College of Marin Facilities Master Plan and Learning Resources Center

Final Environmental Impact Report

June 2020

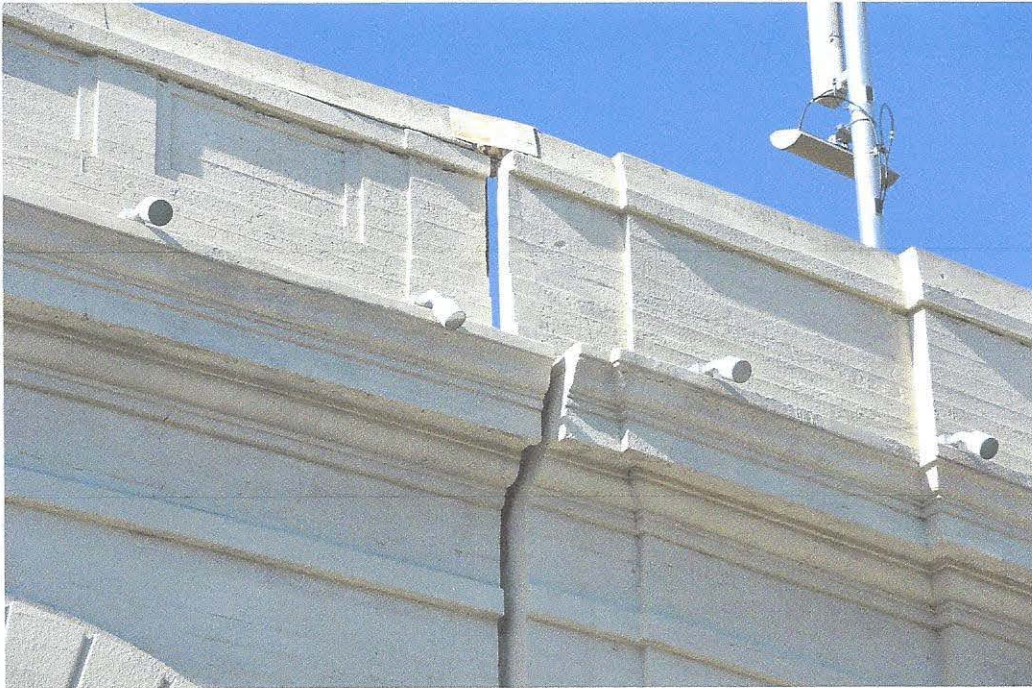
Another campus famously cut by the Hayward fault is UC Berkeley. The campus to the east as shown in this diagram:

Note here the Hayward fault cuts the campus at the Memorial Stadium, the Greek Theatre, and student housing complexes to the south (Clark Kerr) and the north (Stern, Foothill housing).

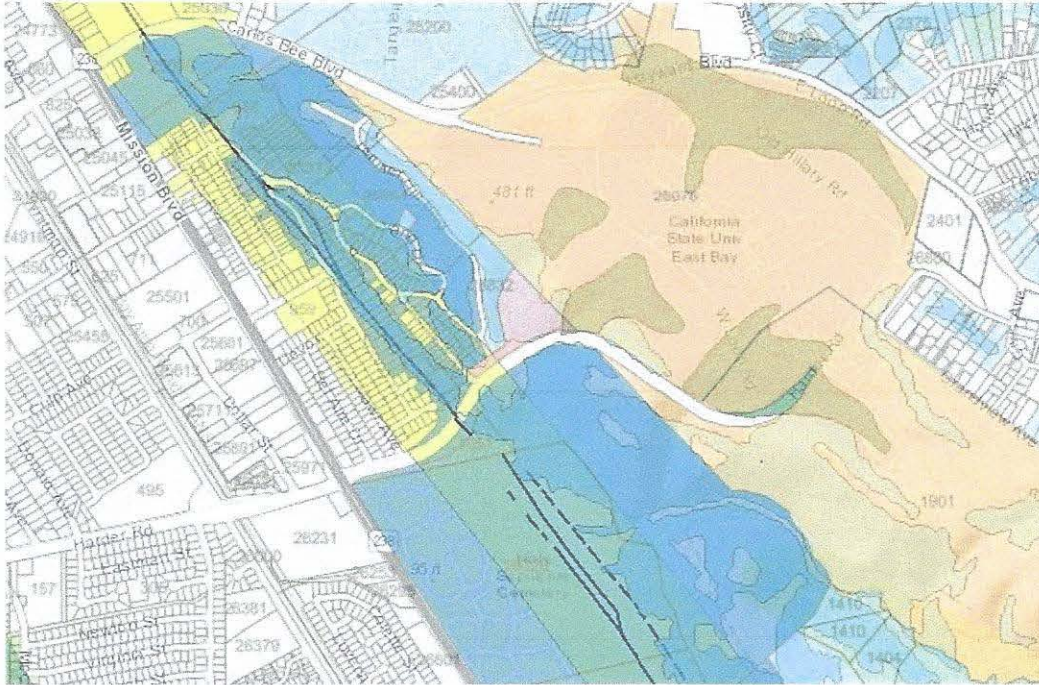
Mills College in Oakland is another example of an educational institution affected by proximity to the Hayward fault, as shown in this picture:

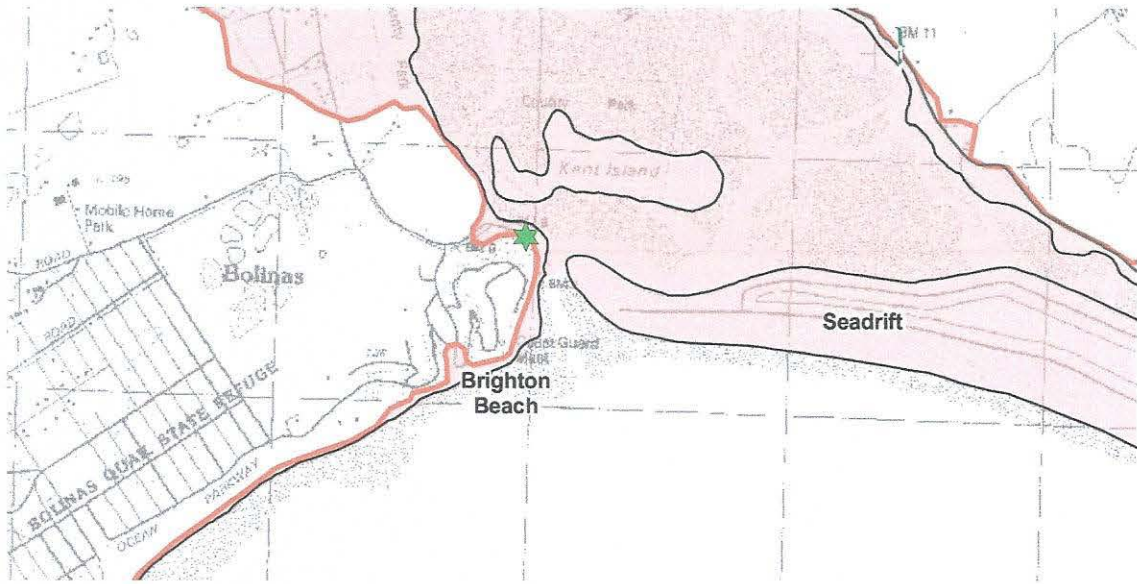
According to the methodology discussed on this site (https://www.conservation.ca.gov/cgs/Documents/Tsunami/AGU08_tsunami_poster.pdf), these maps represent a worst-case scenario of maximum expected tsunami height.

According to the mapping listed above, the 72 Wharf Rd. site (green star) appears to be on the edge of the tsunami inundation zone, as shown in this map:

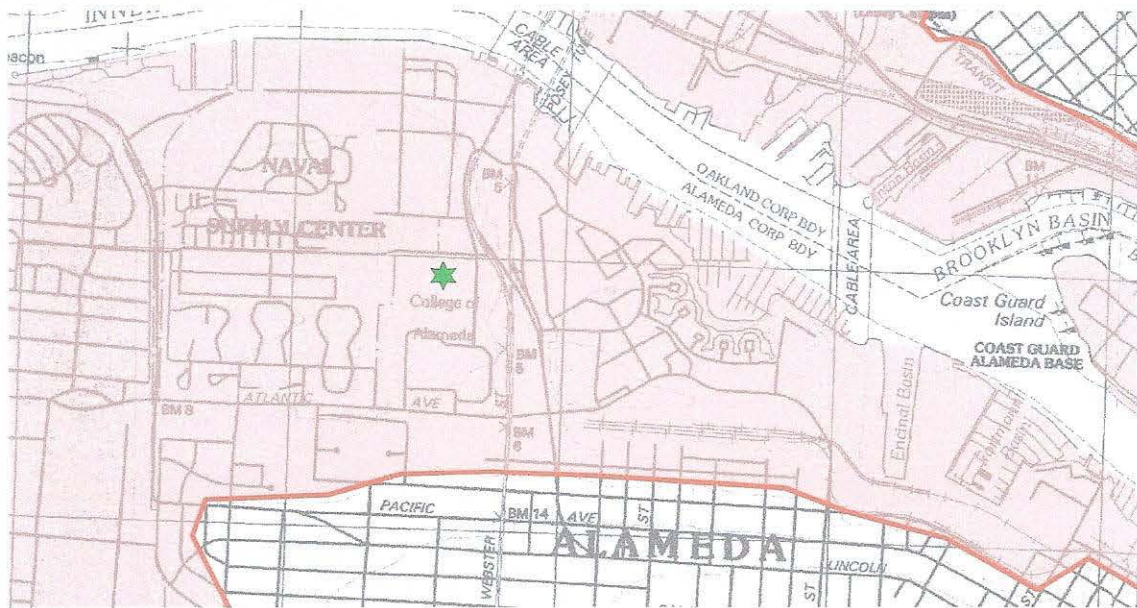
However, this site is not unique in its proximity to the tsunami inundation zone, nor is it the only community college affected by this issue.

College of Alameda (green star), for example, is entirely within this same tsunami inundation zone map, as shown below:

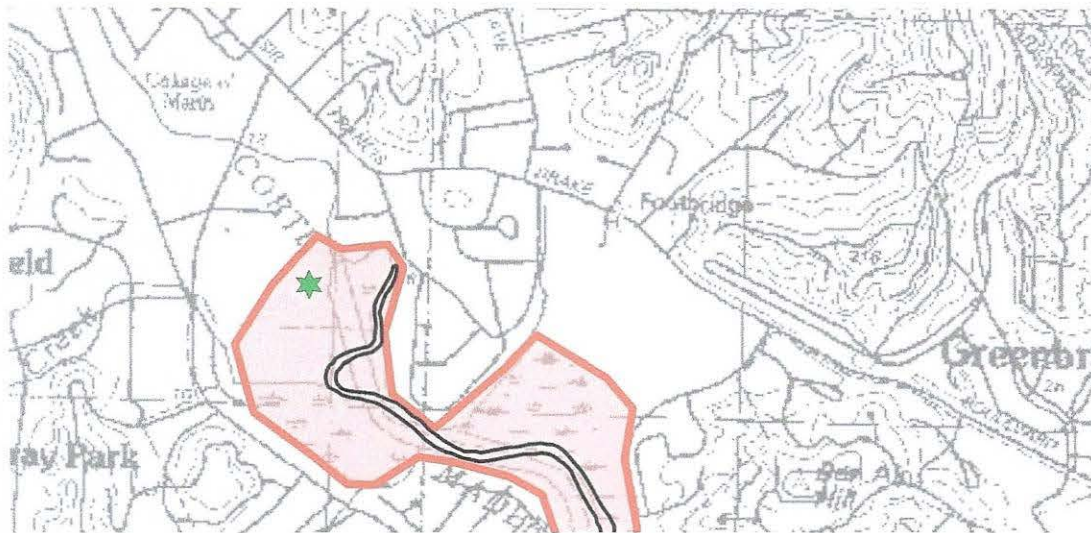
Presumably, this tsunami hazard did not preclude College of Alameda from being built, nor did it impose a restriction upon renovations.

Even more germane to the issue at hand, here is the tsunami inundation map for College of Marin. The Corte Madera Creek provides a connection between tsunami waves and part of the College of Marin Campus:

The green star indicates an area currently under construction, including the athletic track, swimming pool, softball field, and possibly the P13 parking lot.
